RB6798927-2B
Job Sheet 178390

Part Name: Jaw Part

DART AEROSPACE	
TITLE CRIMPER-LOCK NUT COMPRESSOR IMPELLER ASSY AND TURBINE POWER SHAFT	
DWG NO. RB6798927-2B	REV 2
MAT'L 4140/4142	UNLESS OTHERWISE SPECIFIED DIMENSIONS ARE IN INCHES
HEAT TREAT	.XXX ± .010 FRACTIONS ± 1/8
FINISH SEE -2	.XX ± .02 ANGLES ± 1°
SPEC	.X ± .1 SURFACES = 125/✓
DRAWN BY: DD 04/27/2017	1. BREAK ALL SHARP EDGES .015 x 45° OR .015R
CHECKED: RJC 05/02/2017	2. DIMENSIONAL LIMITS APPLY AFTER PLATING
OPPS APPR: AA 05/05/2017	3. INTERPRET DIM AND TOL PER ASME Y14.5M-2009
QA APPR: JL 05/10/2017	USED ON MODEL
APPROVED: JAG 05/18/2017	250 SERIES
SCALE 2:3	DATE 4/27/2017
SHEET 7 OF 8

JAW PART

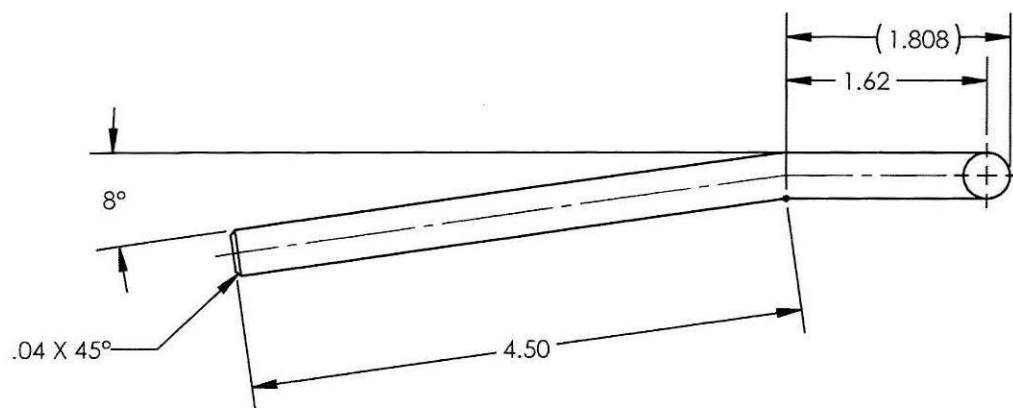
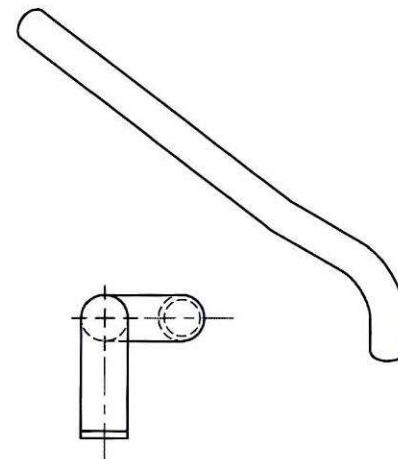
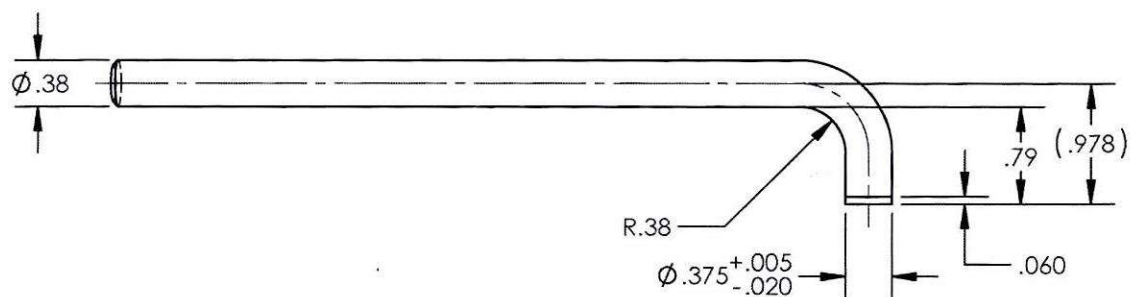
REVISIONS					
REV	ECR	DESCRIPTION	DATE	INITIAL	APPROVED
2	17-0107	-2B CHD MATL WAS 4130 IS 4140/4142. DELETED HEAT TREAT RC 32-36. ADDED DIMS .790, (.978), (.1808), Ø.375±.005, .060.	4/27/2017	DPD	JAG
